```

Cirrus Confidential
Business Information

DELTA LIST OVER PREVIOUS PINOUT RELEASED ON :

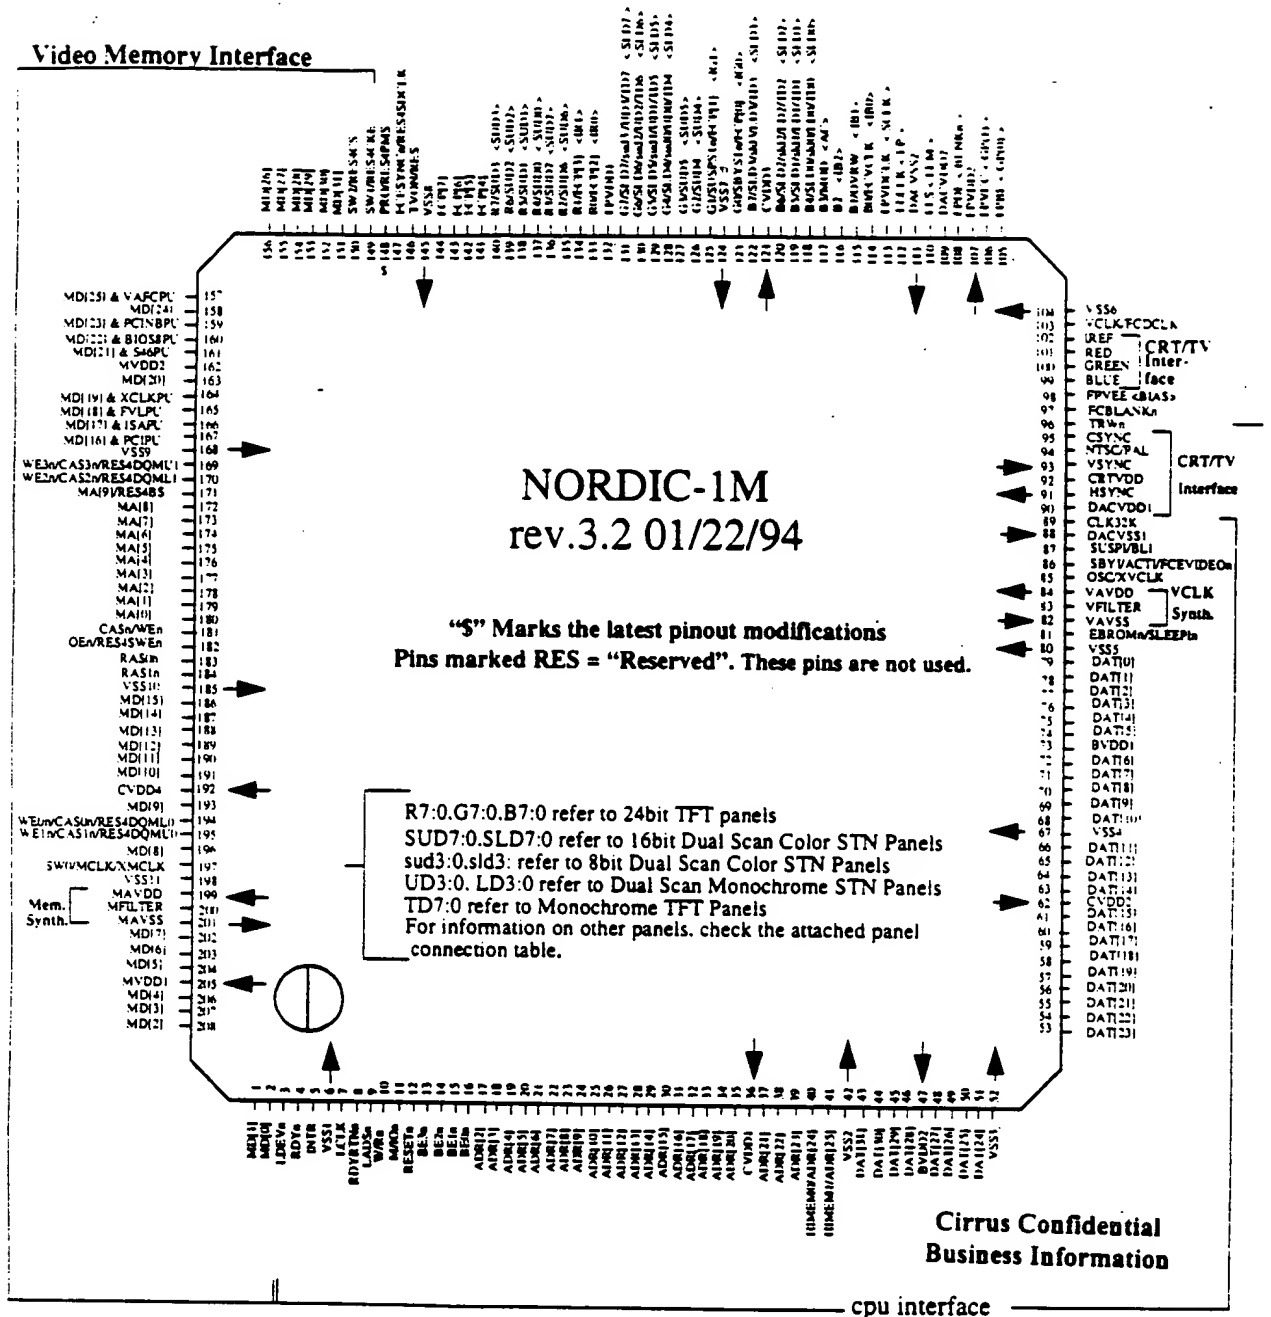
- no POUT on SW2/POUT
- XVCLK moved from SW1/VCLK/XVCLK to OSC/XVCLK. This way SW1/VCLK/XVCLK became SW1/VCLK.

- All panel pins whose names were not starting with the color panel name were changed such that the names start now with the color panel pin (R7, G7, B7 and so on). So it was only a pin name change.

1. Took-out Whisper Support Pins: WWRn, WRdn, WAD[3:0], FPCn.
2. Reduced the number of CPU Address Pins: ADR[24:27] went-away. Use HIMEM to place the chip outside 16MB of memory for linear addressing.

3. Killed CRTVDD and placed CRT Interface on Host Bus VDD.
4. Introduced VAFC pins in a unique pinout configuration in both VESA VL and PCI.
Added VAFCPU a pull-up to enable VAFC (VESA Advanced Feature Connector).
ADR[27:24] become VAFC pins. and R[7:4], G[7:6], CLK32K, SUSPI/BLI, SBYI/ACTI get a configuration for VAFC -> total 14 pins.
SW0/VCLK will be used as VAFC DCLK. losing SW0 pin as panel type when VAFCPU is used.
In PCI bus, no ADR pin will be shared with VAFC.
ASW0PU will be added on MD pins to replace SW0 pin when VAFC is enabled by VAFCPU. SW0PU will read-back in the same register bit as SW0, so the BIOS will not feel any modification in the reporting scheme.
The chip will draw more power in suspend with VAFC.

5. Moved SW2, SW1/MCLK/XMCLK, the two RESERVED pins and TRWn on MVDD to prepare for SDRAM pin compatible option in the next Nordic that supports SDRAMs. It looks that we need only 3 more memory pins to support SDRAM-s so TRWn will not be used. It was moved so it is on the right VDD bus if needed.

6. Moved CVDD3, VSS3, VCLK Synth, H/VSYNC, EROMn, SW0 per Thomas Hung's request to fit the floor plan.

1. Added AUXS1 on D/Cn as an option to be used with CS4231S as CS.
2. Added AUXS2 on EROMn/VADRn as an option to be used for Sound Synthesizer Chip Select.
3. Rearranged 5428 FC pins due to a previous error : R5 and R4 should not be used with FC.
 - FCP[1:0] are shared with G7 and G6.
 - SW2 and the two pins reserved for SDRAM were moved in between Video Memory pins and Panel pins and one of them is used as FCESYNc.
 - OVRW is shared with CLK32K, FCBLANKn is shared with SUSPI and FCEVIDEn is on SBYI.
4. Renamed the External Clock PU XCLKPU instead of XMCPU.

1. Moved some external pull-ups.
2. Added alternate pin functions on panel pins as well as actual schematic name for engineering

1. Added TV-OUT (called also NTSC-OUT) pins on the panel pins

1. Added TVG on EBROMn/AUXS2 and took out VADR as an option on this pin.
2. Put back FCESYNcn on RES4SDCLK as an option (deleted by mistake).

1. Reset became RESETn, active L to correspond with the defined reset signal for VESA VL and PCI.
2. TFT Panels Data Pins R7:R0, G7:G0, B7:B0 changed and all pins got rotated to get them ordered from right to left. Due to this change now Ri=TVRi, Gi=TVGi and Bi=TVBi.

1. Update Panel Data Pins based on Robin's Table.
2. Move MOD pin on a Panel Data Pin used in 18bit TFT.
3. Move OVRW on a 24bit Panel Data Pin.
4. Removed pin configuration for TV-OUT support with digital encoders. All pins marked TV... were removed. As a result, some pins like LLCLK, LFS, FPDE, FPDCLK have one function now.

5. Removed WavePort pins, including AUDVDD: total 7 pins freed. AUX2 and TVG muxed on EBROMn are no longer needed either.
6. Added one more CPU address pin: instead of HIMEM, Nordic has now HIMEM0 and HIMEM1, corresponding to CPU Address 24 and 25 or any other external decode of the high order CPU address bits. In the process of adding this pin, most CPU Interface pins on the right side were moved to the right by one pin.

7. Added CRTVDD supplying HSYNC, VSYNC, CSYNC, NTSC/PAL CRT and TV Interfaces output buffers.
8. EBROMn is shared with TVON, the power-on signal for AD720. So, in ISA bus with on chip BIOS support, AD720 power on cannot be directly controlled by Nordic.

9. Added pins for Analog TV Encoder support - AD720 and MC1377 :
 - a. CSYNC = Composite Sync signal
 - b. NTSC/PAL = 1 -> NTSC, 0-> PAL (for AD720, but it is TV Encoder Dependent)

- c. EBROMn/TVON (see #8).
10. ASW0PU "Alternate Switch 0 Pull-Up" pull-up on pin 155. MD[26] was removed, as SW0 is now not multiplexed.
11. De-multiplexed some of the pins previously multiplexed:

- a. Pin 168 TWRn/RES4PMS is now RES4PMS, a pin reserved for synchronous DRAM support.
 - b. SUSPI/BLI/FCBLANKn is now SUSPI/BLI, not affected by the Feature Connector Enable Configuration

- c. As a consequence of b, pin 97 is FCBLANKn (not muxed with anything). Please note that FCEVIDEOn is still muxed with SBYI/ACTI as before, as Standby Input and Keyboard Activity are less important functions in a system.

- d. SW0 is no longer muxed on VCLK/FCCLK. So VCLK/FCCLK is a pin but it moved to pin 103 in the PVDD area, to be consistent with FC power supply.
12. SW1, muxed on MCLK/XMCLK (pin197) became SW0. This is just a name change to have the switches placed in a more consistent manner.

13. SW1 is now muxed with a reserved pin: RES4CKE, pin 148, which before was totally reserved. The idea here is to go for pu/pd with SDRAM-s for SW2 and SW1, while keeping SW0 on MCLK even with SDRAM-s.
14. Pin 147 is Reserved. It is actually one of the WavePort pins, but placed in-between Memory and Panel VDD busses (on MVDD) for maximum flexibility. To achieve this, the pins on its right were moved to the right by one FPVDD <BIAS> moved down to pin 98 (it was 105).
15. TRWn is now by itself on pin 96, on FPVDD.
16. The names of all flat panel data pins reflect the panel type table attached to this document.

1. On EBROMn/TVON -> EBROMn/SLEEPIn with SLEEPIn an input which if L puts Nordic to sleep (as 3C3[0] and 46E8(3).
2. TVON is now on RES, but TVON/RES is pin 146 and FCESYNCh/RES4SDCLK is pin 147.

1. Pin 148, RES4PMS which was a pin reserved for synchronous DRAM-s, got a function: it is now a programmable output PRO and it is on FPVDD instead of MVDD. The intention is to optionally use this pin to control a switch between 5V and 3.3V, in which case a H level of 5V is desirable. My primary choice for this function is actually NTSC/PAL pin which is on CRTVDD, but if the TV-OUT option is used in a system and a switch between 5 and 3.3V is provided, PRO may be used.
